2006/02/02	
		HuMANDATA LTD. OSAKA JAPAN www.hdl.co.jp	
Date: 2-Feb-2006 15:12:11		SP3 FPGA BOARD	
		DOC. No.	XCM-001
File: XCM001E.sch		Sheet 1 of 1	E2

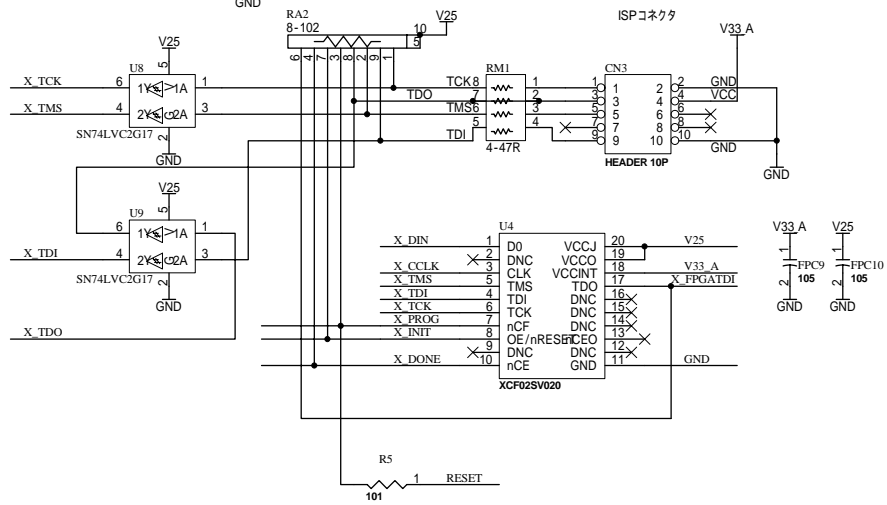
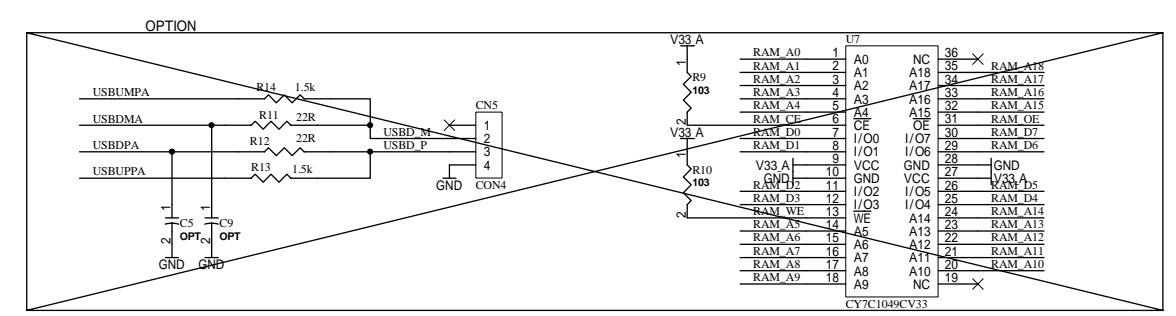
注) CLK1がCLOCKピンに接続されていません
